REVIEW OF THE DCPRA: LETTER REPORT-06/REV.1

**A REVIEW OF SYSTEM ANALYSIS IN THE DCPRA:
COMPONENT COOLING WATER SYSTEM,
REACTOR COOLANT PUMP SEAL COOLING EQUIPMENT**

May 1989

Figure 2.2. Reliability block diagram for top event CC - Component Cooling Water System.

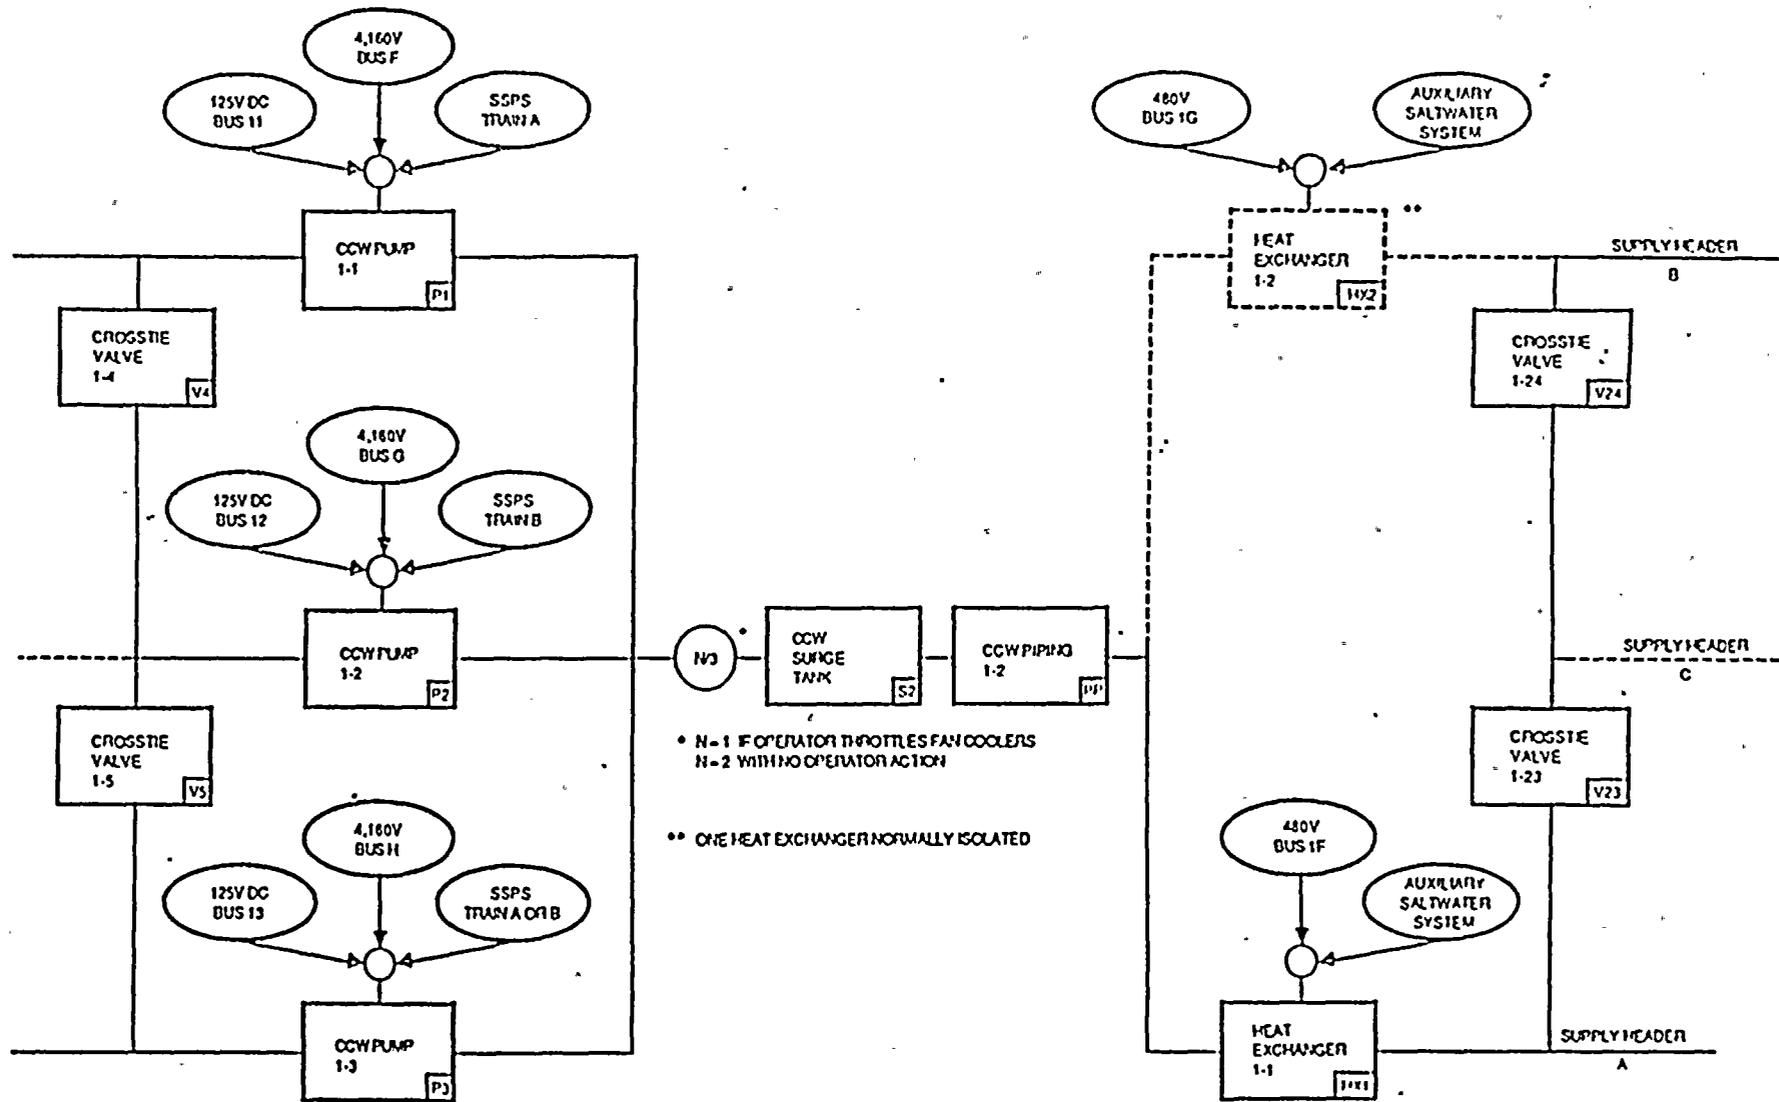
- a. The review found that the DCPRA model of the CCW used the same or even smaller failure rate values for the continuously running CCW pumps as was used for standby pumps (this is against the industry wide experience on the CCWS mentioned in the previous section). Compare, e.g., the pump fails to run failure mode:

The CCW pump "fails to start" failure rate itself seems to be rather low, considering that the normal start of the CCW pumps go through interlocks which prevents the start of these pumps if the lube oil pressure is below 6 psig. This latter requirement, however, involves the operation of lube oil motors and heat exchangers which themselves are subject to failures.

- b. The DCPRA is tacit about the other failure modes of the pumps, such as leakage, vibration, and low (insufficient) output, which are characteristic failure modes of the CCW pumps, mentioned previously.
- c. The DCPRA is tacit about one of the most important failure modes of the CCW heat exchanger, the clogging of the shell side (see also Review of the Auxiliary Saltwater System, Letter Report-04). This failure causes most of the outages of the CCW heat exchangers. The DCPRA simply modelled a CCW system having only a single, maintenance free CCW heat exchanger with a rarely occurring "tube or shell rupture" failure mode. This approach is seemingly conservative but it should be backed up by some verifying calculations. The neglect of any failure of the CCW heat exchangers in the initiator frequency calculation, however, is clearly in disagreement with the experience (see Table A.2).
